AGENDA
HISTORIC PRESERVATION BOARD
City Commission Chambers
January 25, 2024 8:30 A.M.

AGENDA
DESIGN REVIEW COMMITTEE
January 25, 2024

**HISTORIC PRESERVATION BOARD
DESIGN REVIEW COMMITTEE
STAFF REPORT
January 25, 2024**

Project #	HPB24-005
Project Type	Painting of Unpainted Brick on Exterior of Building
Property Address	111 S. Florida Avenue
Historic Name(s)	The W. Fisk Johnson Building
Historic District; FMSF#	Munn Park Historic District; #91-56-14C
Owner	Professional Developers of Central Florida LLC
Applicant	Mr. Zach Miller
Zoning; Future Land Use; Context District; SPI; CRA	C-7; Regional Activity Center; Urban Center; N/A; Downtown CRA
Existing Use	Commercial
Adjacent Properties	Commercial
Previous Approvals	Awning & Window Signs, 4/27/2006 (2006-084); Replace awning, 4/29/2009 (2009-049); Fence, 8/7/2017 (HPB17-144); Minor Exterior Alteration, 11/29/2022 (HPB22-233).

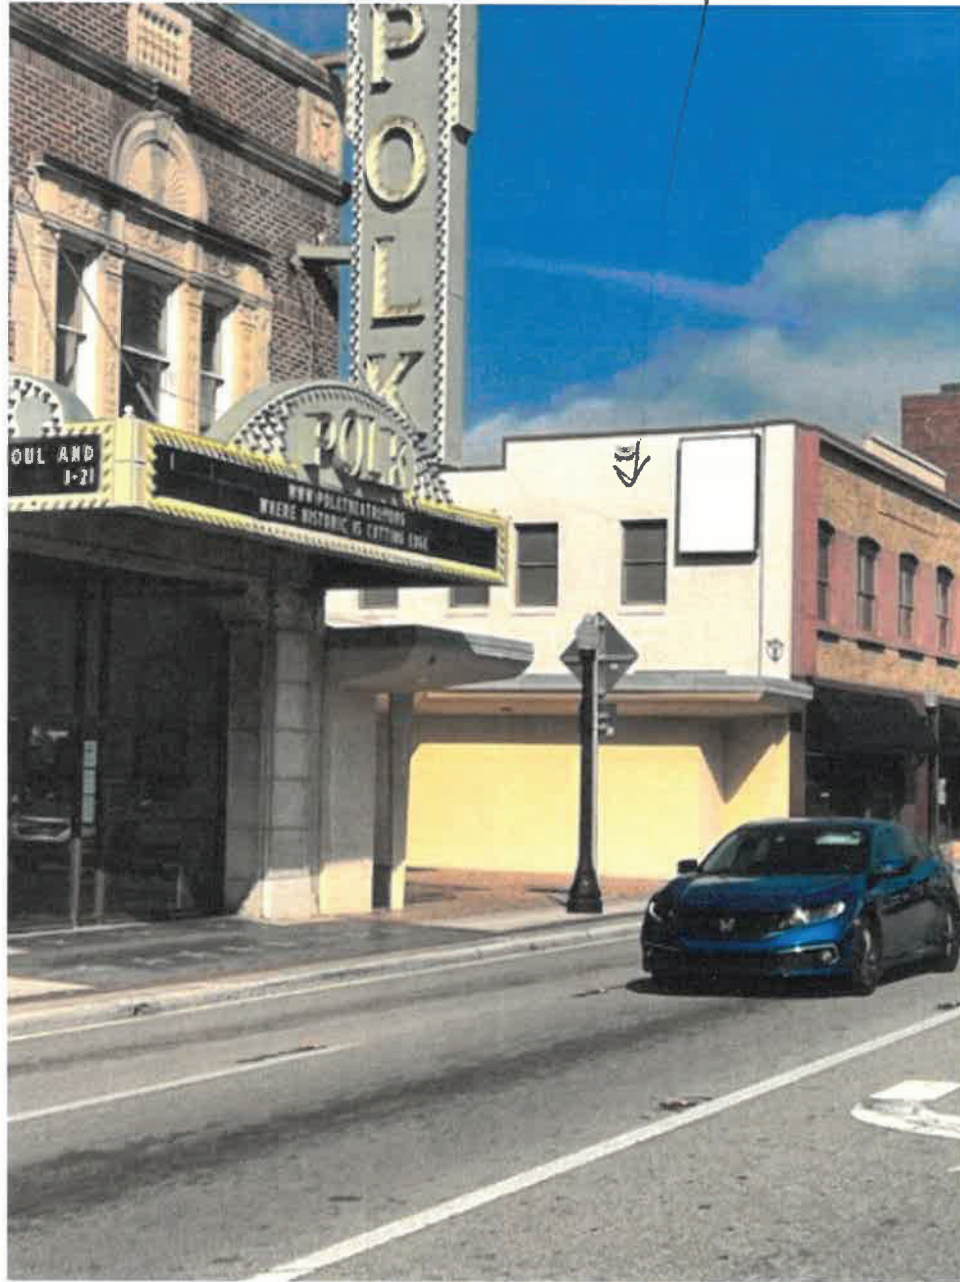
The Applicant seeks approval to retain the paint over the natural brick on the front façade of the building, which was completed in approximately July 2023, without Design Review approval by staff. According to the Applicant’s contractor [Mr. Robbie Collins, Jr. with Corrosion Control Inc., Mulberry, FL company], the system used on the exterior of the brick building consisted of power washing, priming all brick with Sherwin-Williams Loxon primer, and finishing with two coats Sherwin-Williams Sher-Cryl high-performance acrylic coating. In the contractor’s opinion, to remove this system would require abrasive blasting, which would likely damage the brick underneath.

Staff finds that painting the unpainted, natural brick on the front façade of the subject building to be inconsistent with both the Standards and Design Guidelines, as well as adversely affects the historic character of this building. While harsh methods of paint removal, such as sandblasting or high-pressure washing, are not recommended as these methods can damage the brick underneath the paint, alternative removal methods exist, such as alkaline and/or organic solvent paint removers, which are gentler and are recommended to safely remove paint from brick.

Staff recommends that the Applicant and/or Owner remove the paint applied to the previously unpainted brick on the front façade in a gentle manner to not damage the brick; this recommendation does not apply to the non-historic brick at the bottom of the front façade storefronts.

Denial of the request as submitted.
